Explanation of Significant Differences

**Tremont City Barrel Fill Site
German Township, Clark County, Ohio**

February 2018

figure 2

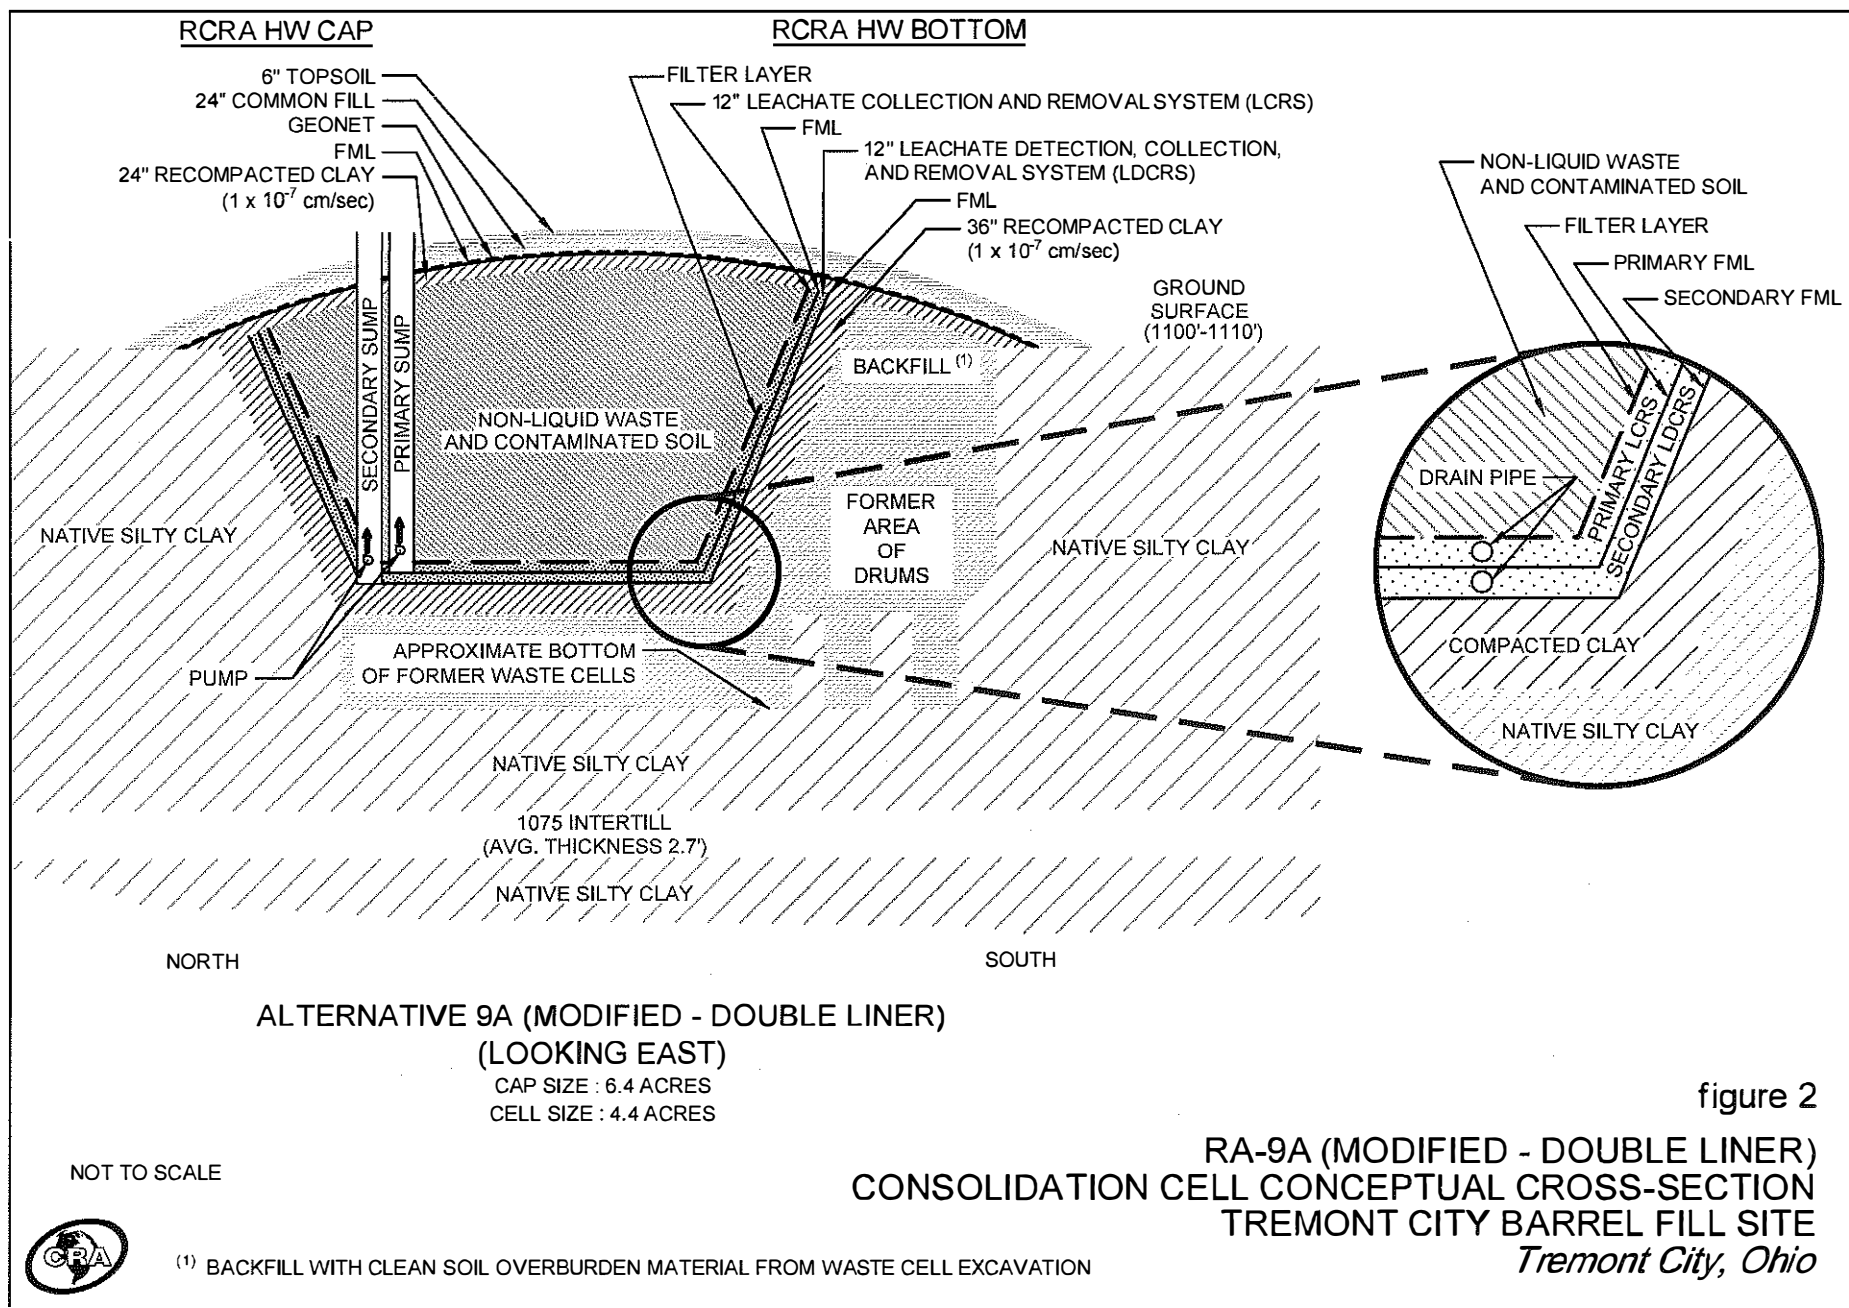
Double Liner System Instead of Slurry Wall and Clay/Leakage Collection System

Instead of a single flexible membrane liner accompanied by a slurry wall and compacted clay/leakage collection system, these remedy components will be replaced by a second flexible membrane liner. While both options are considered to be comprised of two impermeable layers that would encompass the newly-engineered waste cell, EPA has concluded that the standard double flexible membrane liner system, which is currently required by RCRA regulations at hazardous waste disposal sites, will provide an equivalent or enhanced level of protection to human health and the environment. Re-compacted clay will lie beneath the double-liner system, and there will be a drainage layer and drain pipes in both flexible membrane liners to remove any remaining liquid that might be within the contained wastes. See Figure 2 for a conceptual diagram of the new double-liner containment system.
